| KEYSTONE ELECTRONICS CORP.                                     |  |                              |         |
| PART NAME  |  | SNAP RIVET                   |         |
| $\pm 1^\circ$  |  | C                            | 3441    |

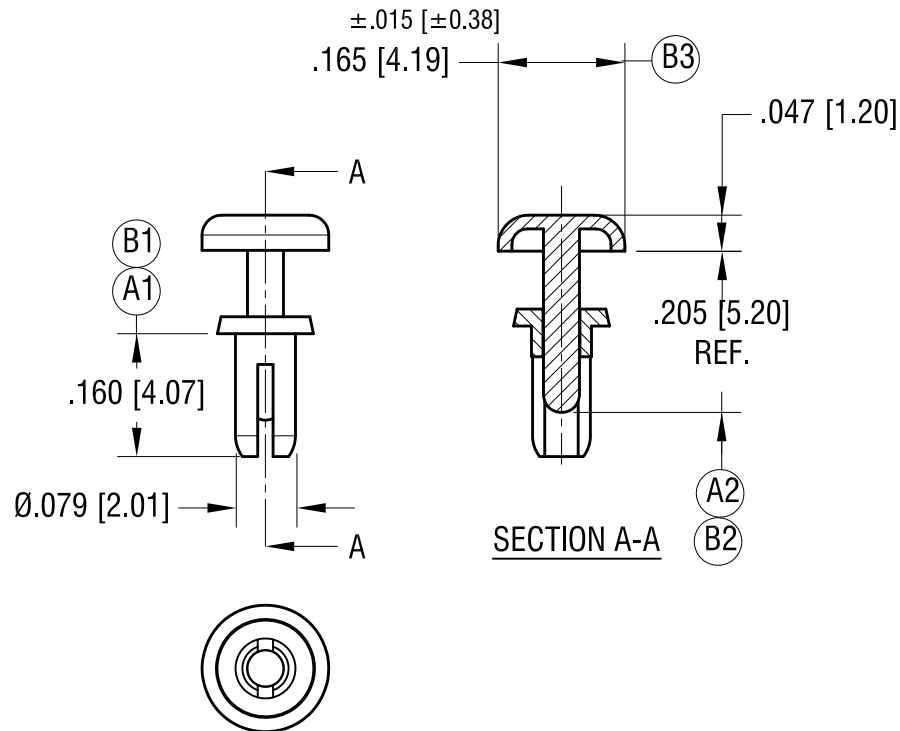
| 8.27.21 | (B1) WAS .170, (B2) WAS .210<br>(B3) WAS $.165 \pm .010$ , ECN 21-098 | B    |
| 7.15.21 | (A1) WAS .160, (A2) WAS .220<br>CHANGE AS PER ECN 21-069              | A    |
